BRAUM'S ADDITION

SITE PLAN TO SERVE
BRAUM'S ICE CREAM STORE
ROCKWALL, TEXAS

I have had an opportunity to review the draft site plan for the Braum's location at Yellowjacket and SH-205 and there are some areas that need to be addressed. My comments are as follows:

Agenda Item: P&Z 91-20/SP/FP/CUP - Hold Public Hearing and Consider Recommending Approval of a Request from Braum's for a Conditional Use Permit for a Structure with Less than 90% Exterior Masonry Facade, a Site Plan and Final Plat on a Tract of land Located on Yellowjacket and SH-205

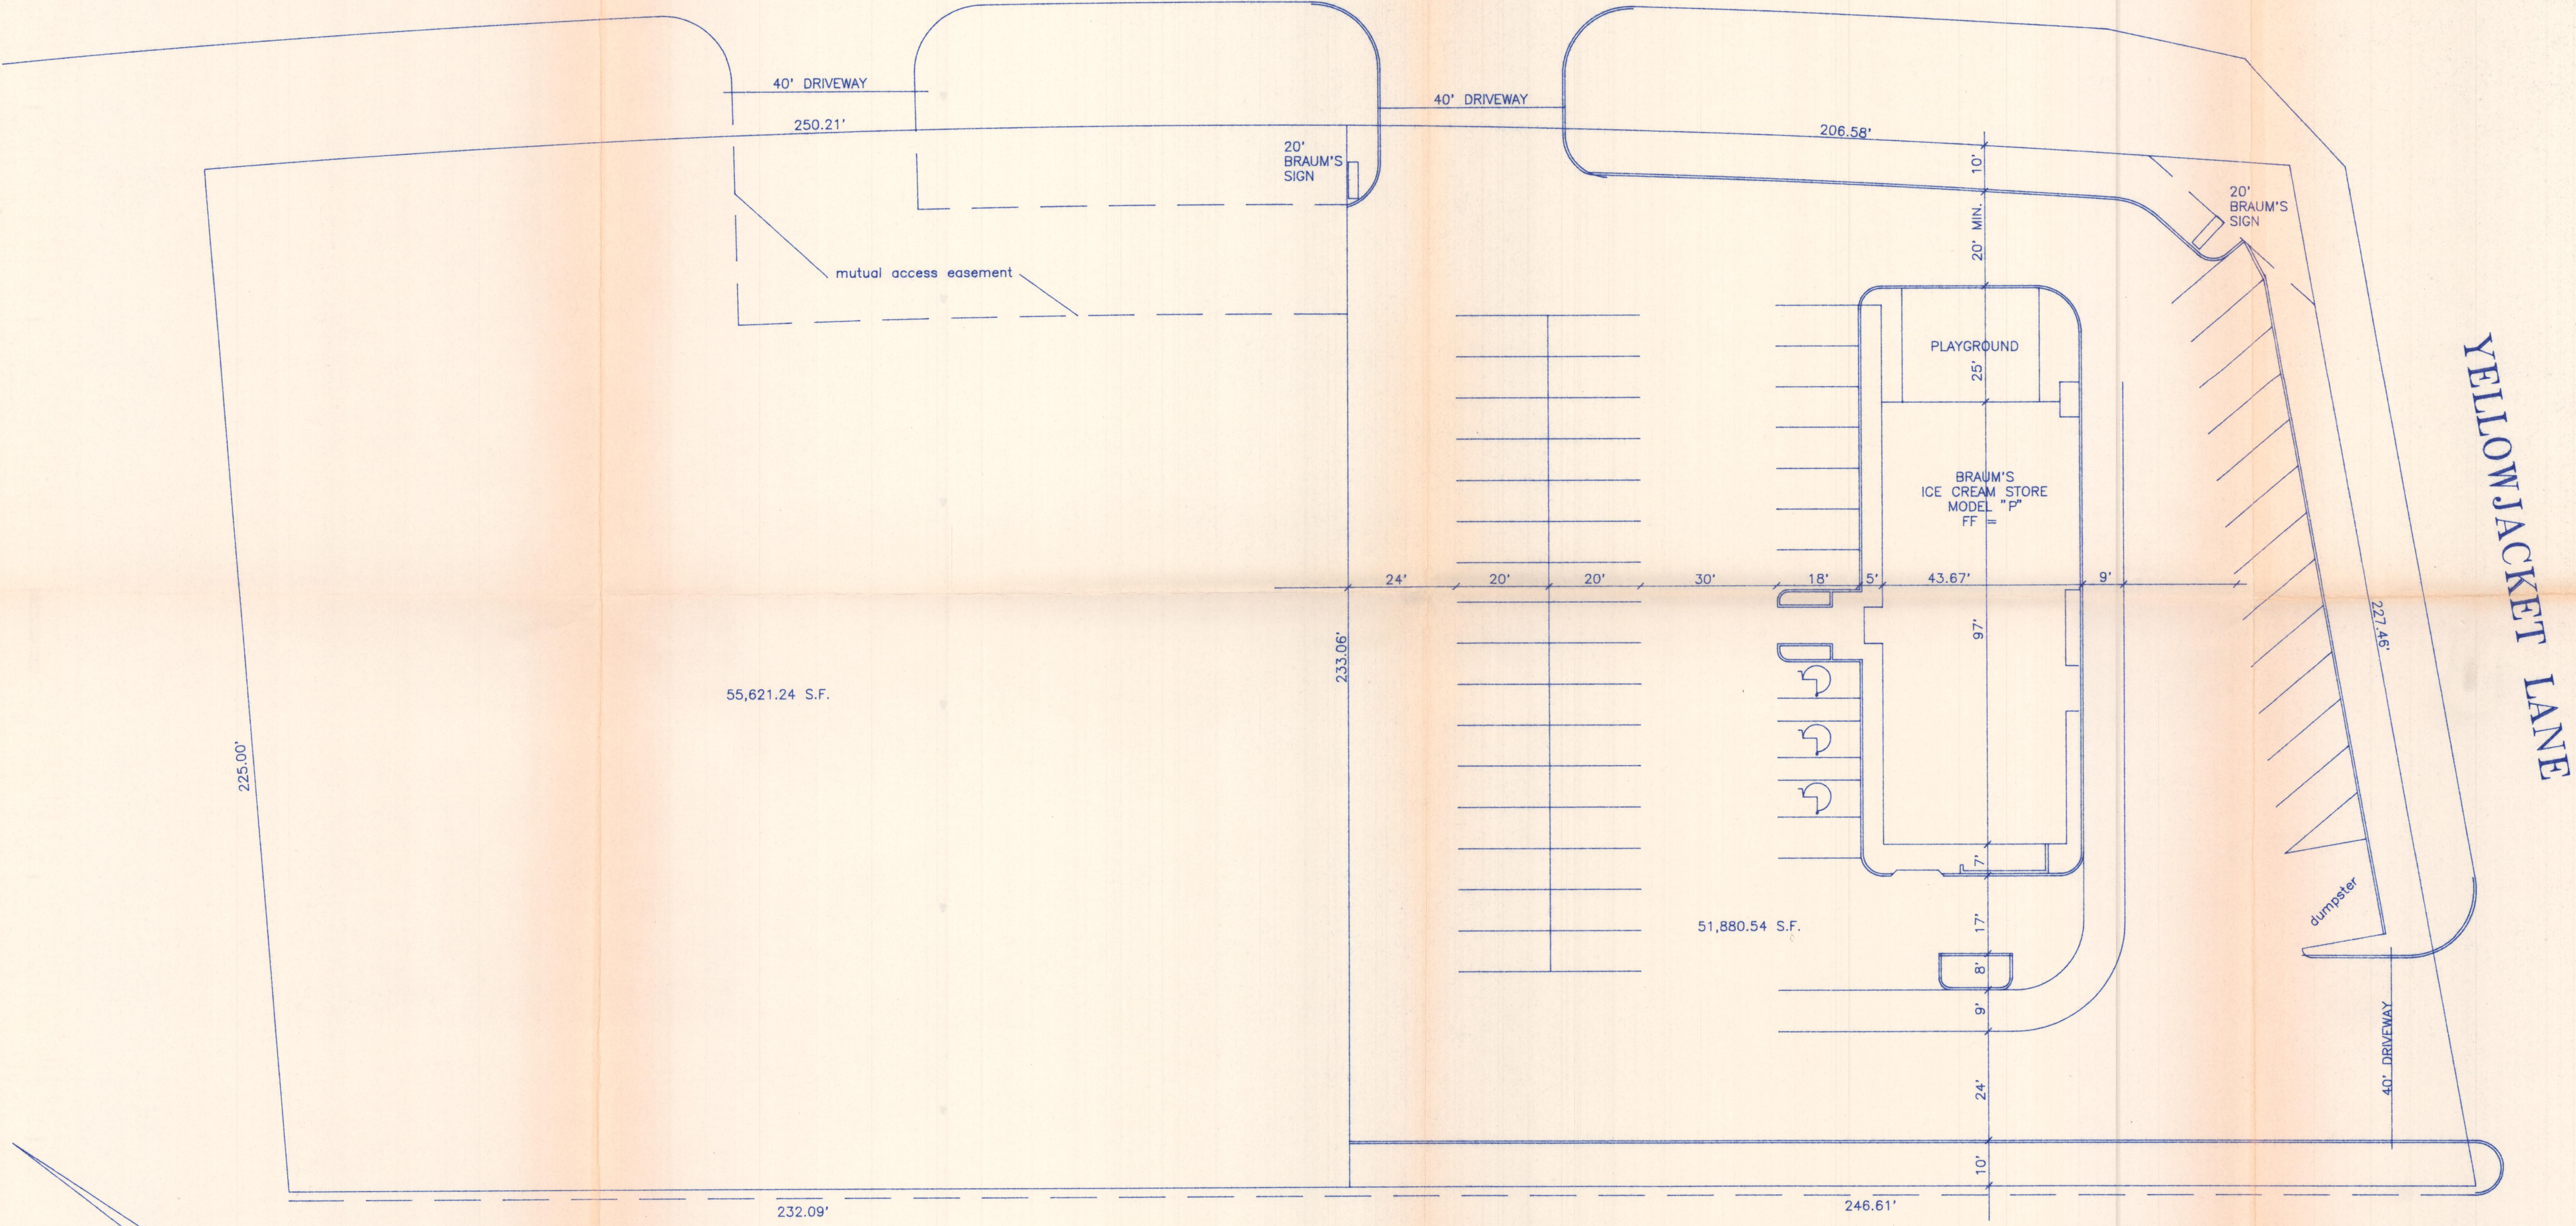
Landscaping - There is no landscaping information provided and you will need to provide that on your submitted site plan. You are required to provide landscaping internal to the parking lot totalling 5% of the parking lot area. On the enclosed marked up copy of the site plan I have shown an example of what could be done. If you need another copy of the landscaping ordinance let me know and I will get one to you.

✓ Signage - You are limited to one free standing sign not exceeding 20' in height or 60 sq. ft. in area. The sign must also be 10 feet from the street right of way line. Your plan shows two free standing signs.

Building Location - The building and the angle parking along the south property line are too close together for two way traffic. This drive would need to be signed as one way.

1. The two entrances onto SH-205 are located approximately 100 feet apart. Our current standards require that drives be located at least 200 feet apart unless a waiver is granted. The entrances are also unusually wide for the type of traffic that will be generated with your development. I would recommend that you consider a configuration of two 30' driveways approximately 150' apart and with the drive closest to Yellowjacket located approximately 150' from the intersection. Please indicate the radius dimensions on the drives. I would recommend that they be at least 20'. As we have previously discussed, when SH-205 is widened there is no median opening planned for this site.

2. I would also recommend that the entrance off of Yellowjacket be reduced from 40 feet. As shown the outside radius of this entrance will conflict with the radius of the adjacent driveway into the apartment. I would recommend that you curve the drive to form a 90 degree intersection with the road and move it off of the property line 27 feet at the

intersection. This will allow a full 15 foot radius for each drive. Again, there is no median opening planned for this area when the road is widened to a 4 lane divided section.

Dumpster - The dumpster needs to be screened with a wall made of the same material as the main structure with a solid screen gate.

SITE & GRADING PLAN
B.J.T. LEWIS SURVEY, ABSTRACT NO. 225
CITY OF ROCKWALL, ROCKWALL COUNTY, TEXAS

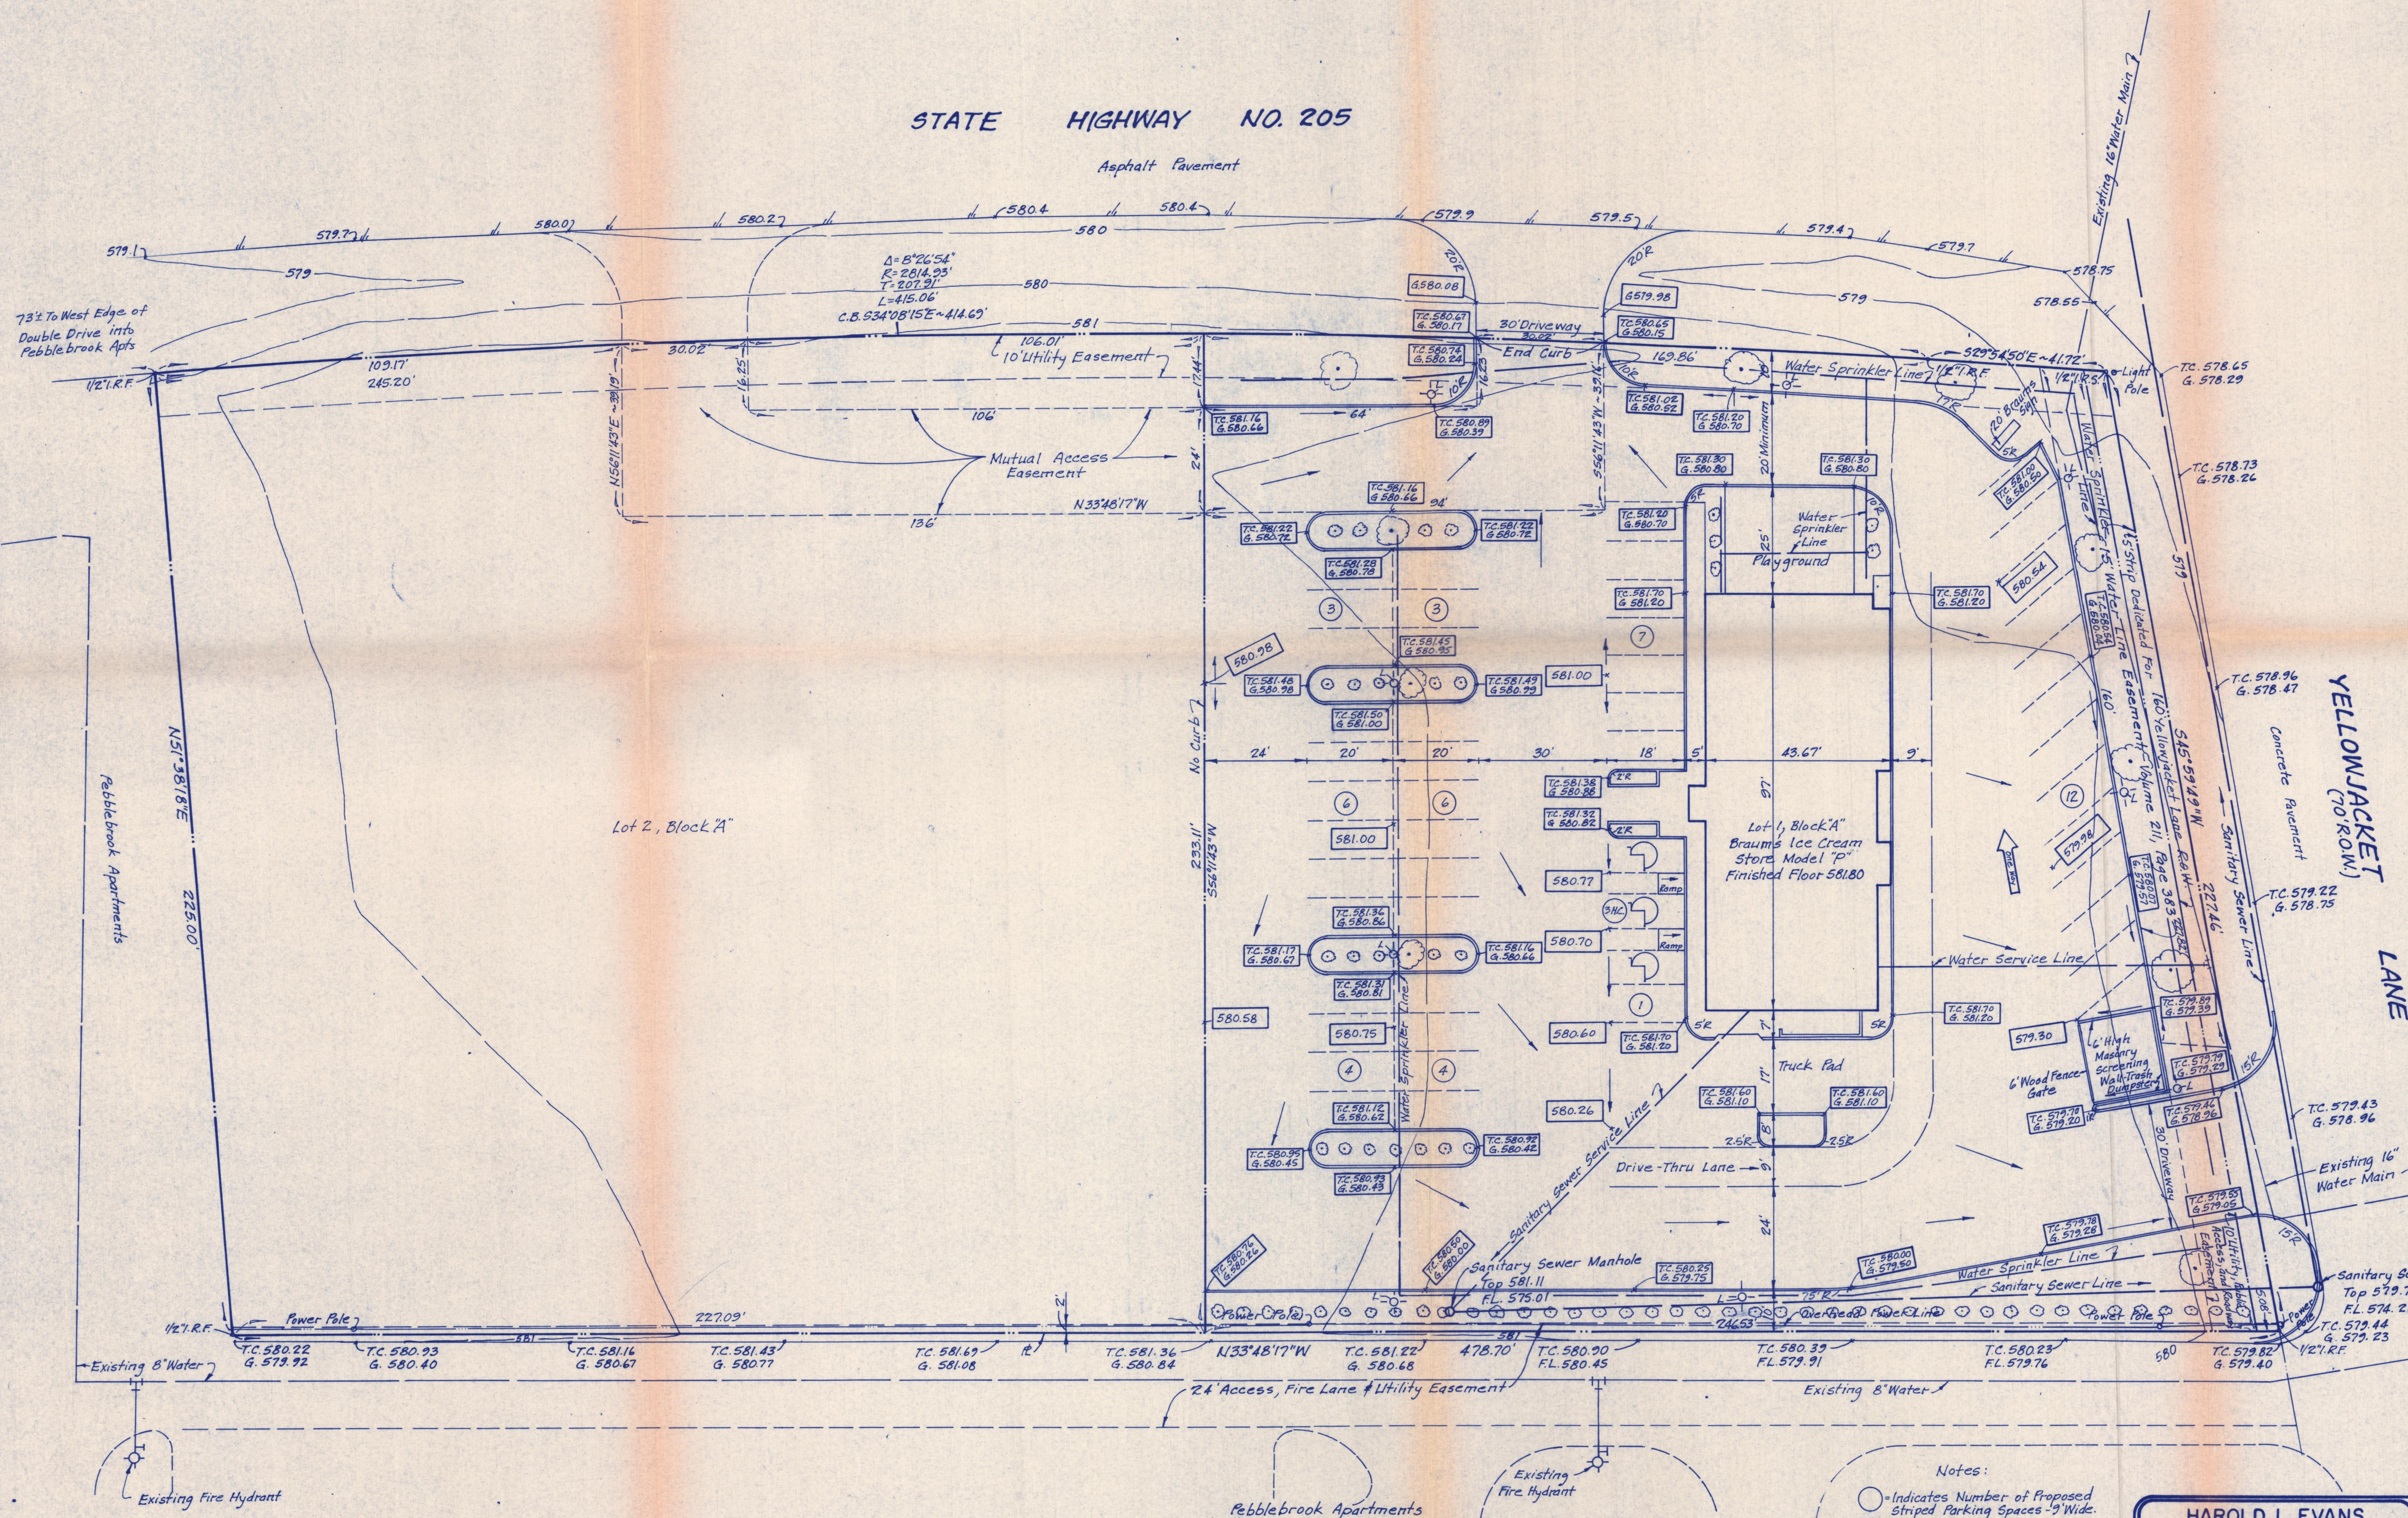
no median opening

grass in Row + sprinkler system out in this area

parking lot 23,391 \$ 5% = 1,169 \$
 have ~~1,994~~
 need add island + curbs for ^{need 275}
 walking

total site = 31,909 \$ 15% = 7786
 total landscaped = 7325
 need 460

need 3 trees in parking lot

screening wall needs to be of same material as building - would be better w/ metal door on screening wall

do not enter at front of building drive

grading plan needs to be approved by C.E.

drives need to be further apart - 170' apart inside to inside

extend roadway + access + utility along yellow jacket

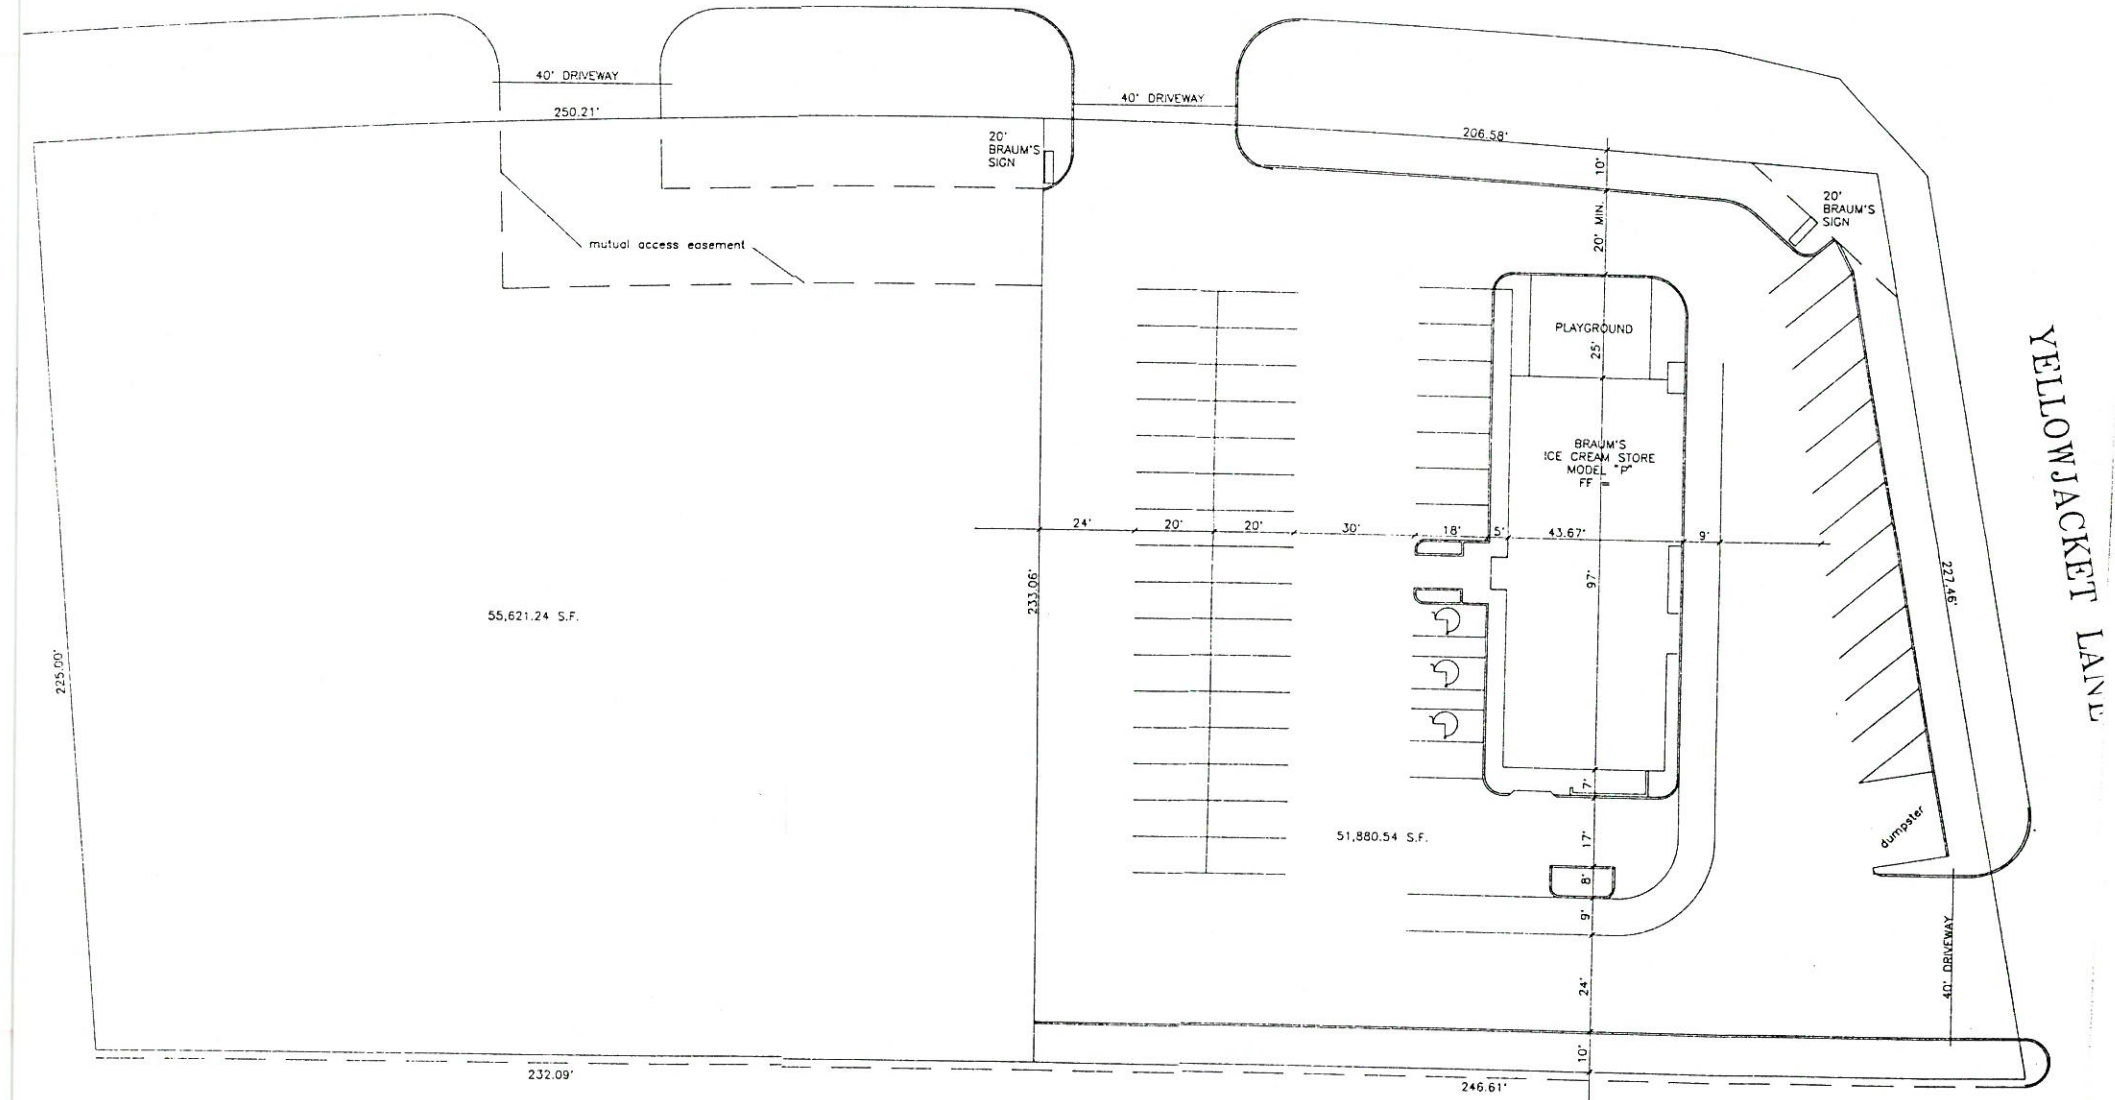
Signage - they are limited to one free standing sign not exceeding 20' in height and 60 sq. ft. in area. The plan shows two free standing signs.

Building Location - The building and the angle parking along the south property line are too close together for two way traffic. This drive would need to be signed as one way.

1. The two entrances onto SH-205 are located approximately 100 feet apart. Our current standards require that drives be located at least 200 feet apart unless a waiver is granted. The entrances are also unusually wide for the type of traffic that will be generated with the development. It was recommended to them that they consider a configuration of two 30' driveways approximately 150' apart and with the drive closest to Yellowjacket located approximately 150' from the intersection. The radius dimensions on the drives were also requested. It was also recommended that they be at least 20'. It was pointed out that when SH-205 is widened there is no median opening planned for this site.

2. It was recommended that the entrance off of Yellowjacket be reduced from 40 feet. As shown the outside radius of this entrance will conflict with the radius of the adjacent driveway into the apartments. Again, there is no median opening planned for this area when the road is widened to a 4 lane divided section.
